PLAN COMMISSION MEETING AGENDA

MONDAY, MARCH 25, 2024 AT 4:30 PM

TO: Plan Commission
DATE: March 25th, 2024
SUBJECT: 1207 Boomer Street, Conditional Use Permit - CUP

TO: Plan Commission
DATE: March 25th, 2024
SUBJECT: 672 Johnson Street, Conditional Use Permit - CUP

[illegible]

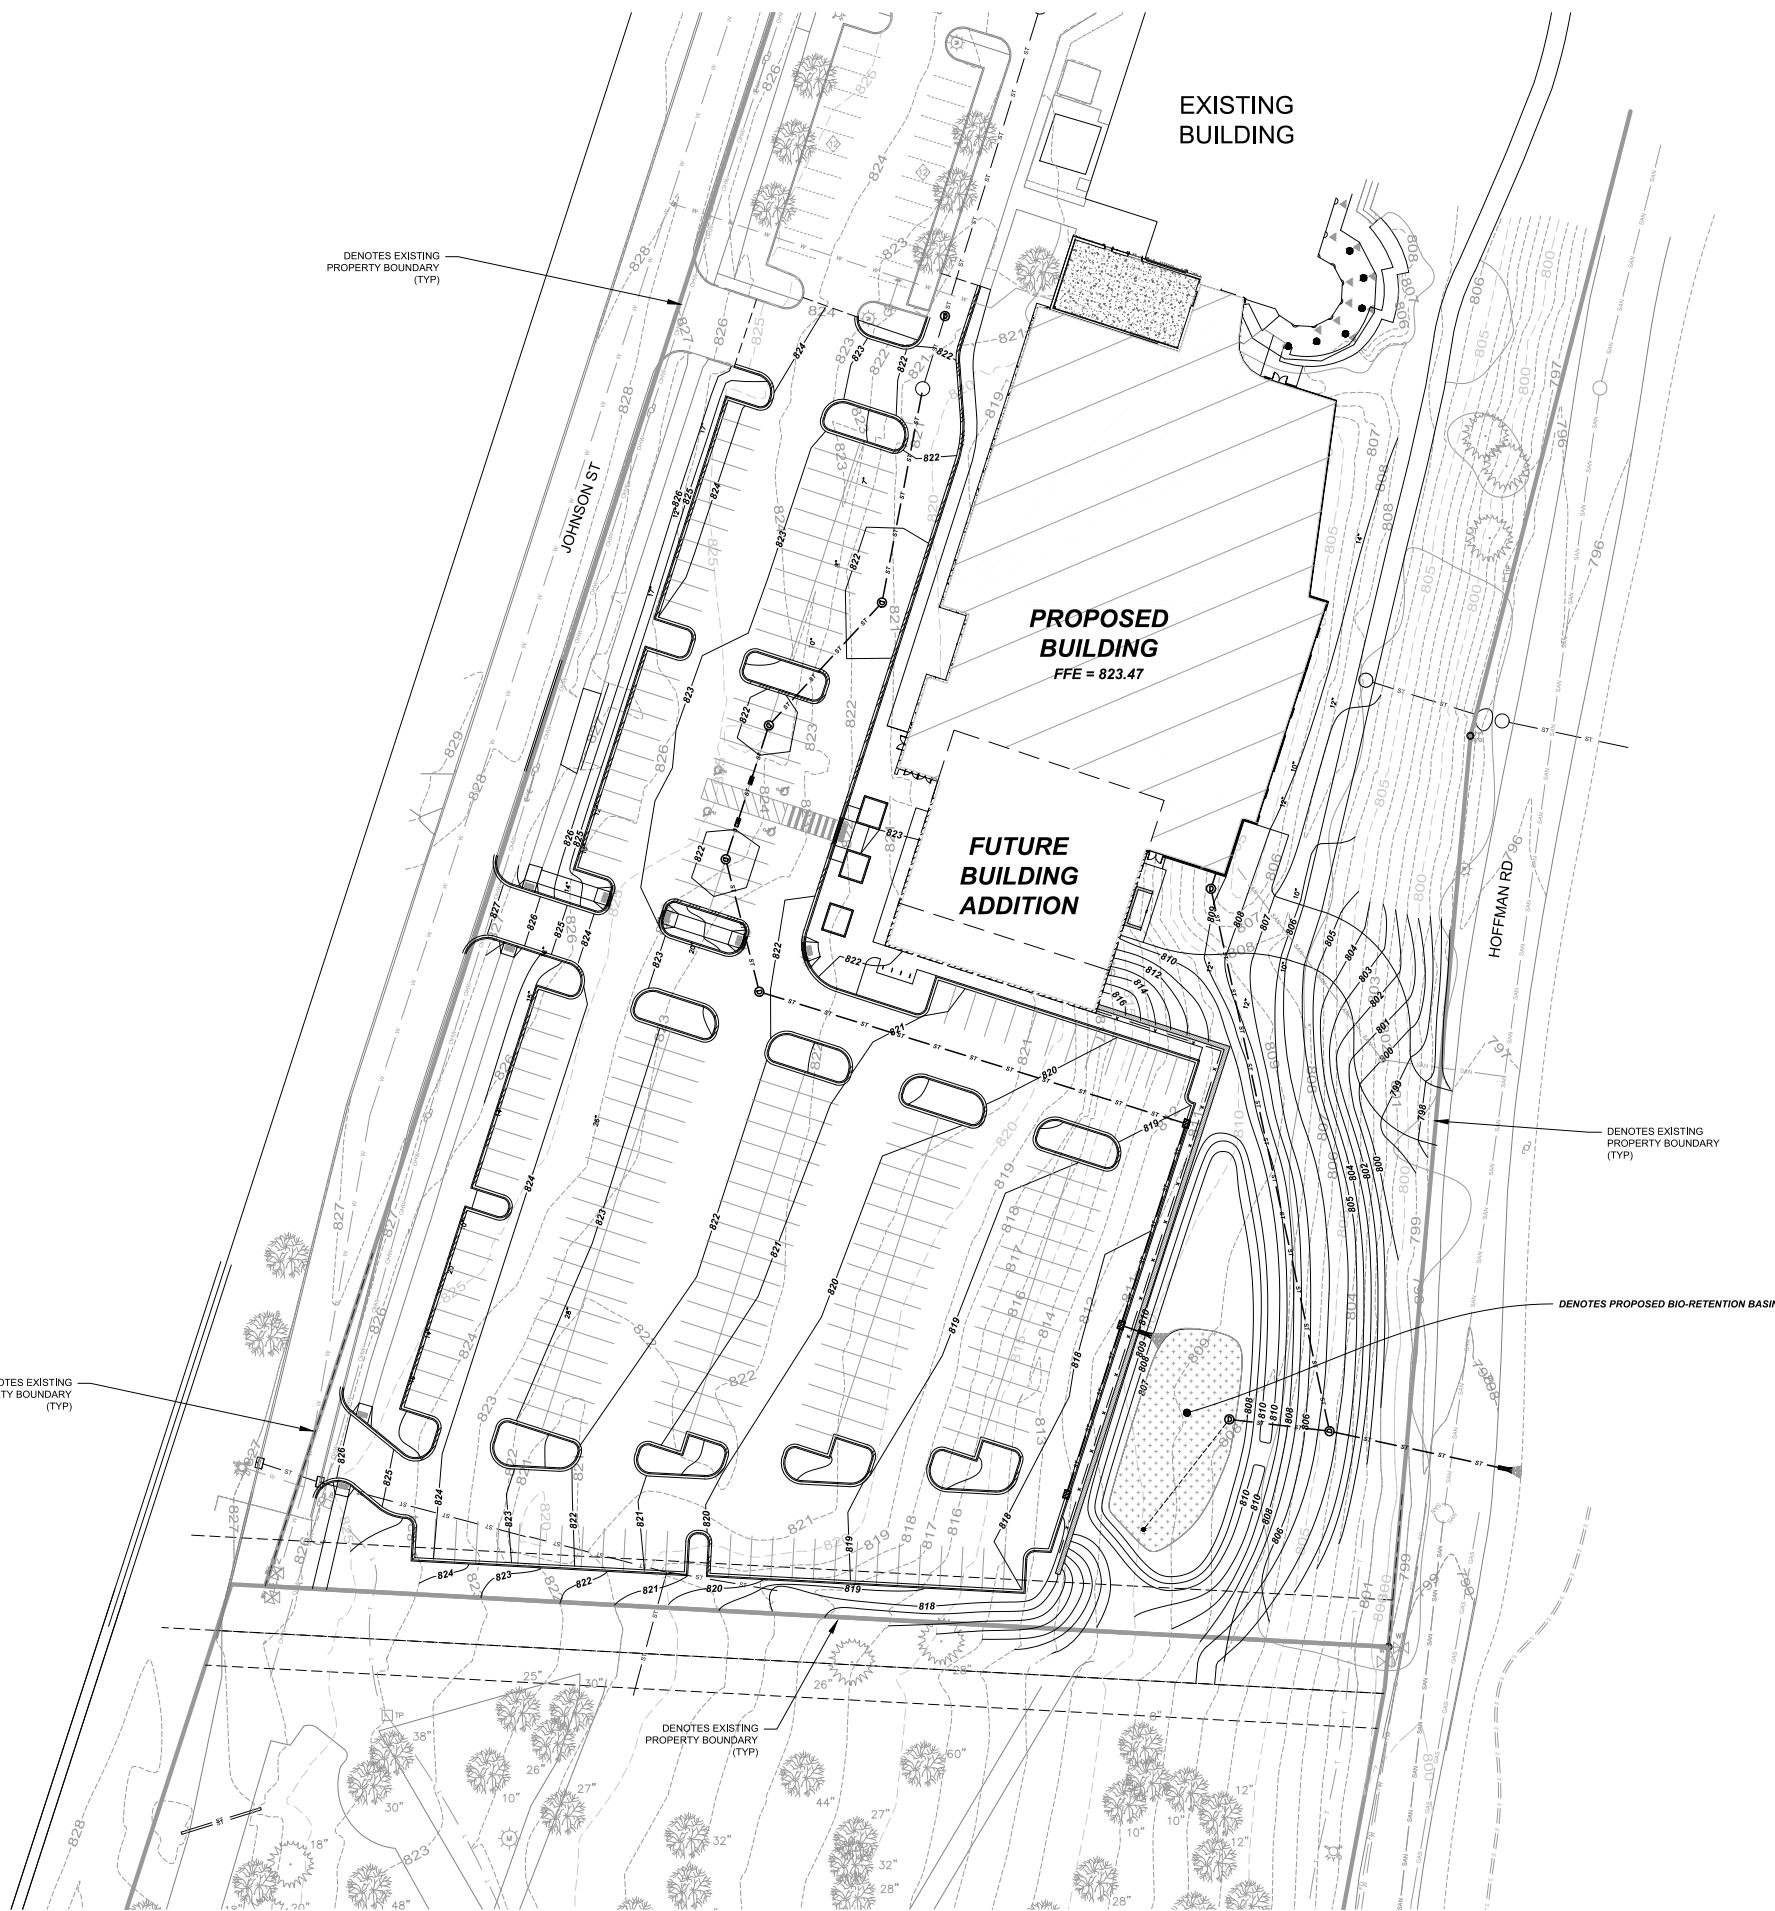
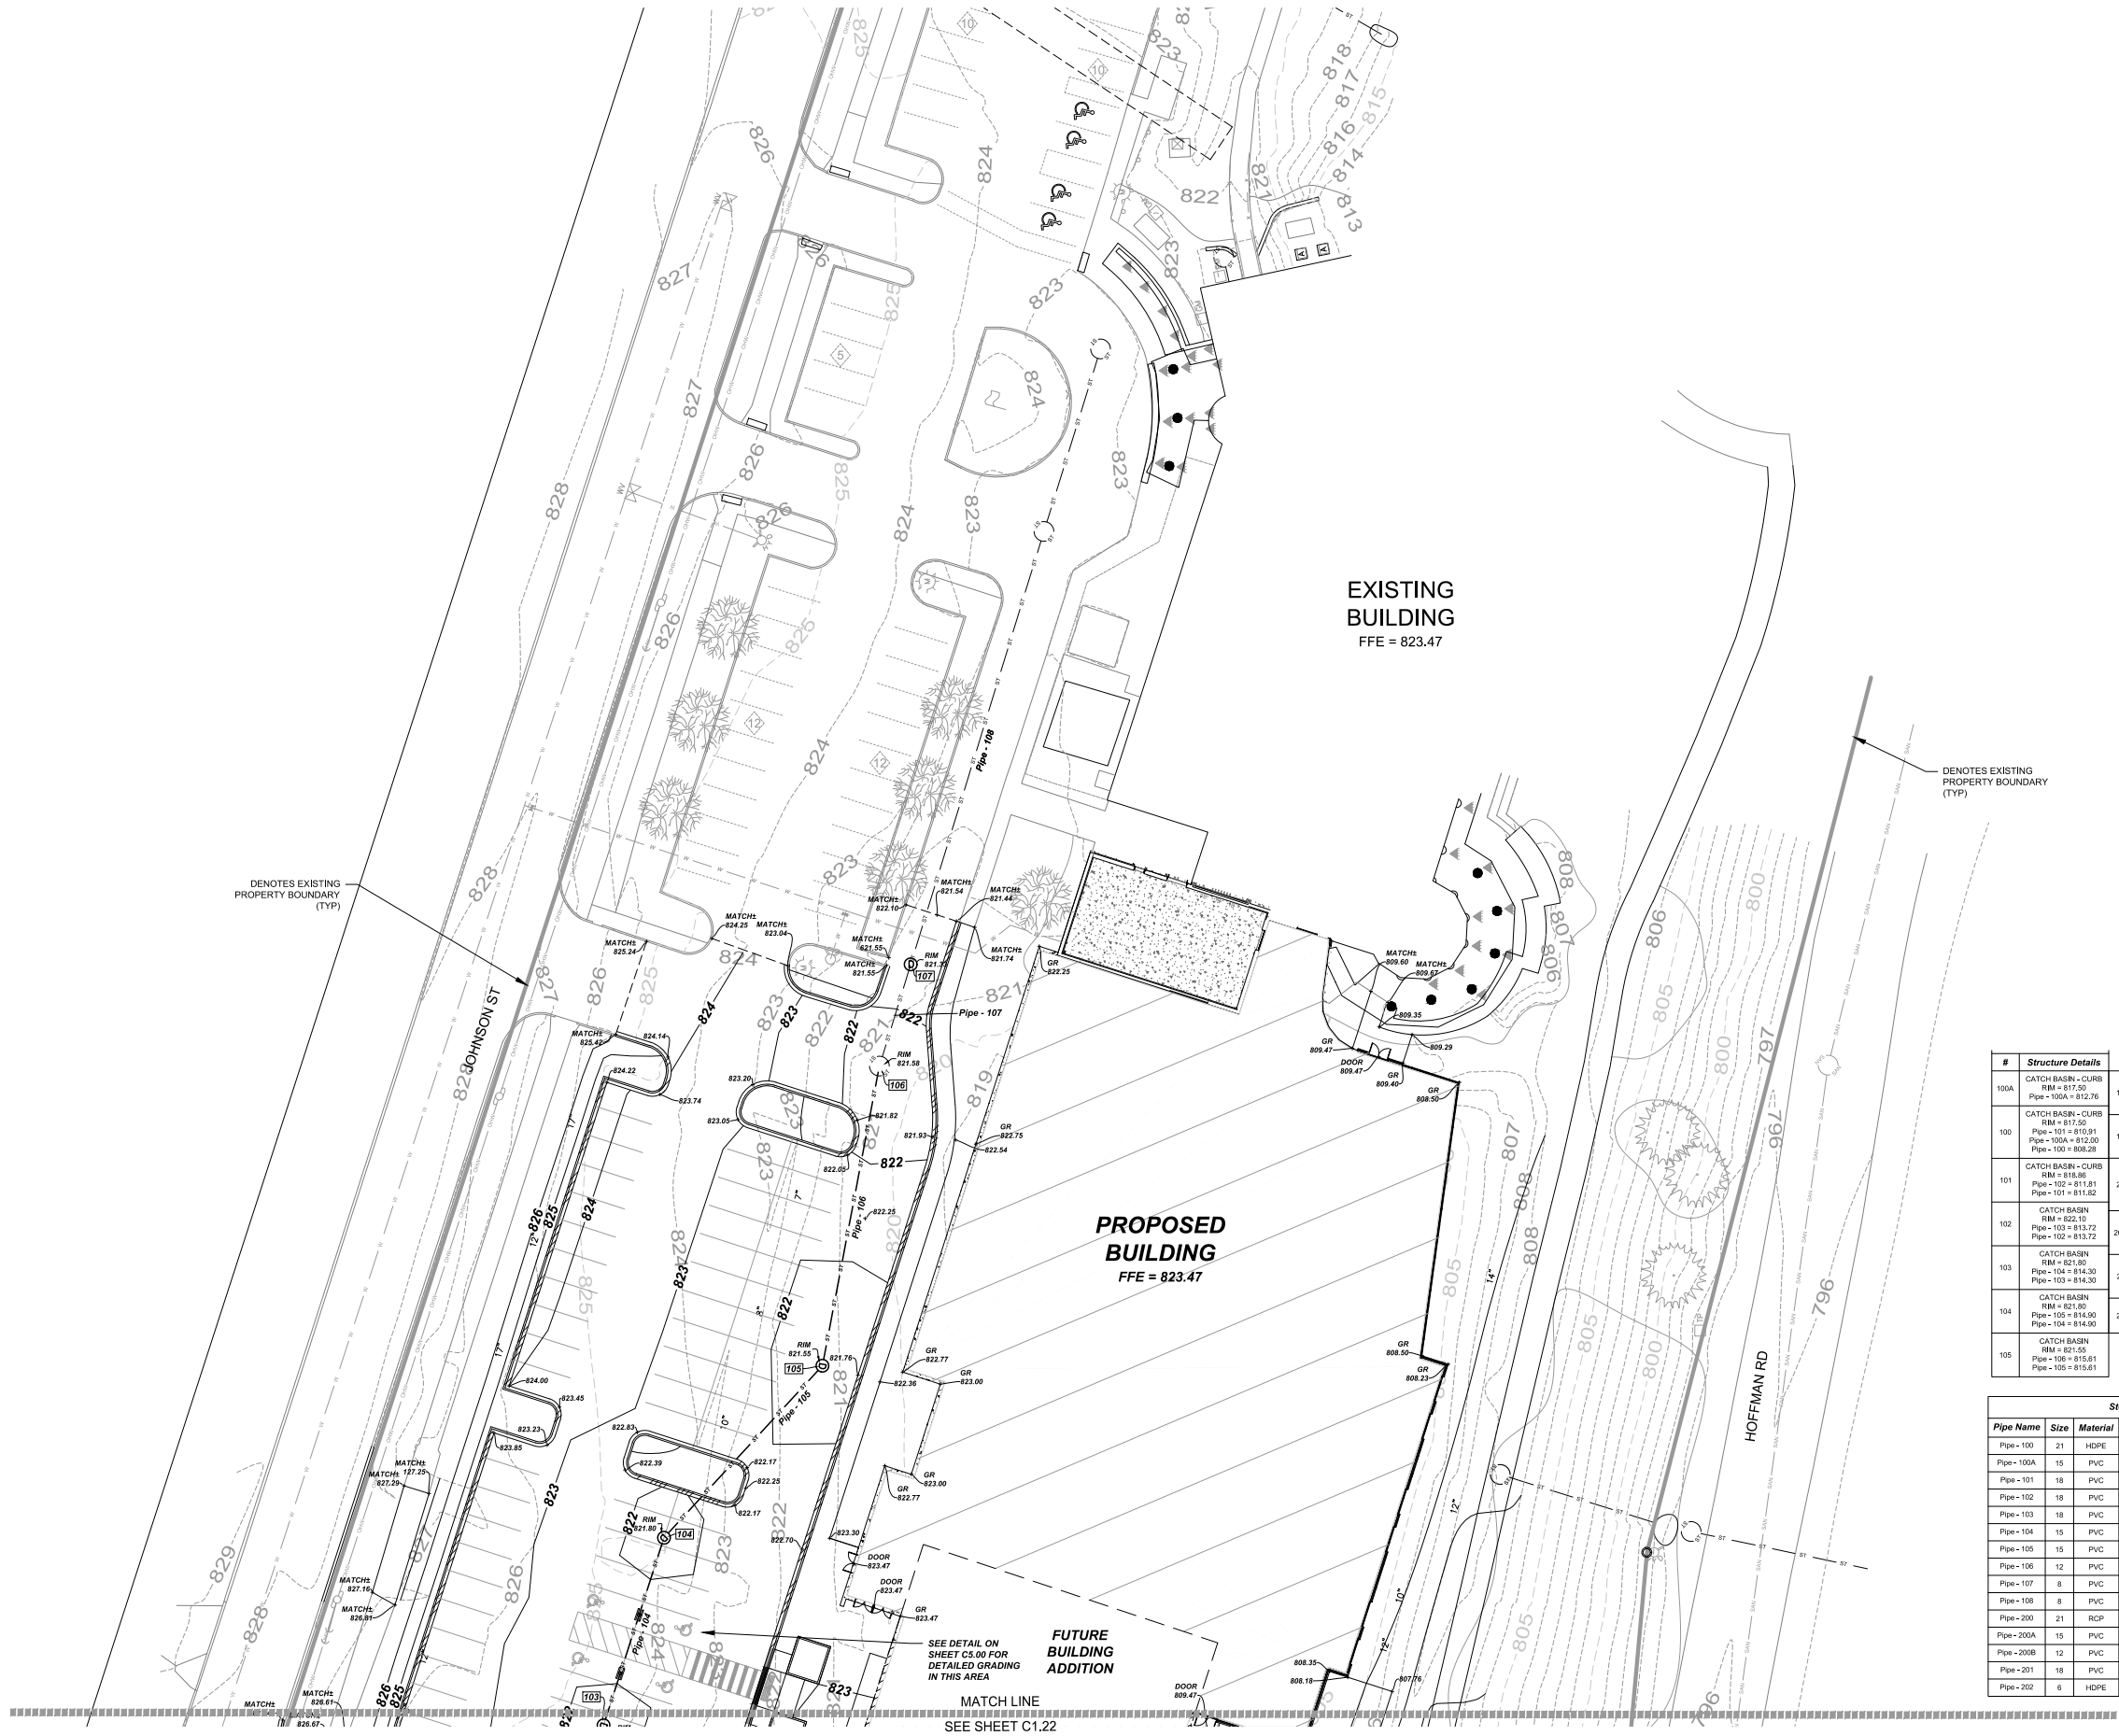
- (h) Parking lot design shall employ interior landscaped islands with a minimum of 400 square feet at all parking islands, and in addition shall provide a minimum of one landscaped island of a minimum of 400 square feet in each parking aisle for every 20 cars in that aisle. Aisle-end islands shall count toward meeting this requirement. Landscaped medians shall be used to break large parking areas into distinct pods, with a maximum of 100 spaces in any one pod. **Needs to be waived, requesting removal of the median island requirements in certain locations.**

- (n) Where such developments are proposed to provide a new location for a business already located within the community, a required condition of approval for the new development shall be a prohibition on conditions of sale, lease or use of the previously occupied building or site which provide limits beyond the range of applicable local, state or federal regulations. If such limits are required, the applicant may seek City approval to demolish the previously occupied structure and prepare the site for some future development. **Needs to be waived, the use of existing YMCA site to be determined at a later date.**

- (p) The Plan Commission may waive any of the above standards by a three-fourths' vote of members in attendance, but only if supplemental design elements or improvements are incorporated into the project that compensate for the waiver of the particular standard. **Three standards will need to be waived to approve this proposal.**

| Response | Requesting a waiver separating the 97 stalls from the 100 stalls on south end of the parking lot. Site is land locked and for program purposes to maximize parking, requesting to removed the requirement of the Median island only. |

| Response | Waiver, YMCA working with Board and community leaders to identify highest and best use of existing site |
